REMARKS

The present Amendment is responsive to the Official Actions mailed on July 9, 2010 and August 30, 2010, and is timely filed within the three-month shortened statutory period for filing a response. Claims 29-34 and 36-38 were pending at the time of the Action. Claims 29-32 stand withdrawn from consideration. Claim 38 has been canceled. Claims 33, 34, and 36 have been amended, and new claims 39-43 have been added. No new matter has been added. In view of the amendments and remarks made herein, reconsideration of the Examiner's rejections and Notice of Allowance of all pending claims is earnestly solicited.

Fig. 9

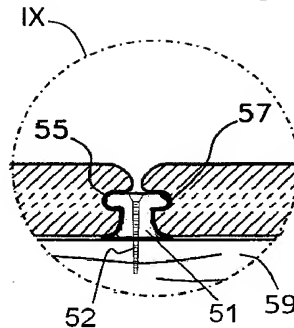
In the Official Action, the Examiner did not accept the drawings submitted on December 17, 2009. The Examiner averred that the applicant "failed to point out where the fastener's tapered flush mounted head, tapered shank, specific length, diameter, threading, etc. were originally presented in the application as filed." (Official Action 3.) According to the Examiner, the new drawings contain new matter. Applicant respectfully disagrees.

Figure 9 merely shows a conventional metal fastener 52 driven through the anchoring device. Since Figure 9 is not drawn to scale, it does not convey any specific information about the dimensions of the fastener 52. Thus, Figure 9 does not convey information about the specific length and diameter of fastener 52. See M.P.E.P. § 2125 ("Proportions of features in a drawing are not evidence of actual proportions when drawings are not to scale.") Accordingly, Applicant respectfully submits that Figure 9 does not introduce new matter relating to the specific length and diameter of fastener 52.

The Examiner also contended that the tapered flush mounted head, tapered shank, and threading of fastener 52, as shown in Figure 9, constitute new matter. Applicant respectfully disagrees. As stated above, conventional or well

known features or devices need not be disclosed in detail. The description need only describe in detail that which is new or not conventional. The alleged tapered flush mounted head, tapered shank, and threading of the fastener illustrated in Figure 9 are all conventional or well known features of typical fasteners. As such, Applicant does not need to describe in detail conventional features of well known fastener 52. If the Examiner believes that any feature of the fastener shown in Figure 9 is novel or not conventional, Applicant respectfully requests the Examiner to specify such novel or not conventional features. Absent a showing that the features of the fastener 52 shown in Figure 9 are novel or not conventional, it is reasonable to conclude that fastener 52 merely discloses a conventional fastener. Accordingly, Applicant respectfully submits that the fastener shown in Figure 9 does not constitute new matter.

In the previous Amendment, Applicant merely amended the drawings to include the subject matter described in the present application as filed. As seen in Figure 9 of the present application, which has been reproduced above, the anchoring device is capable of having a metal fastener 52 driven therethrough. The present application, as filed, states that the anchoring device may be "capable of having a metal fastener driven through." (Present Application 24.) In addition, the present application, as originally filed, states that "[a] staple, nail or screw is passed through anchoring device 1 into joist beam 59." (*Id.* 32.)

For the foregoing reasons, Applicant respectfully submits that the previous amendments to the drawings did not introduce new matter. Applicant also submits that the drawings comply with 37 C.F.R. § 1.83(a) because they show all the features recited in the claims.
